AMENDMENTS TO THE DRAWINGS

Application No. 10/803,174

Docket No.: E0196.0005

FIG 10

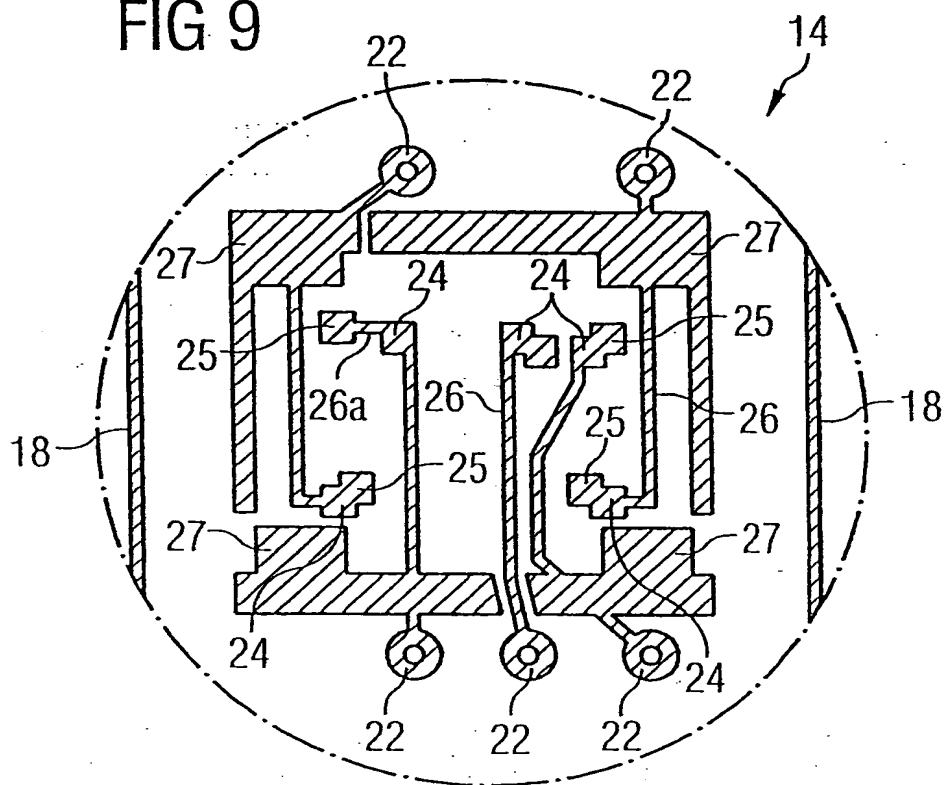
The drawings and specification were objected to for failing to disclose spacer 60 in Figure 10. Attached please find a revised copy of Figure 10 as well as an amendment to paragraph 66 of the specification reciting the spacer 60 as shown in Figure 10.

The attached sheet of drawings includes changes to Figure 10.
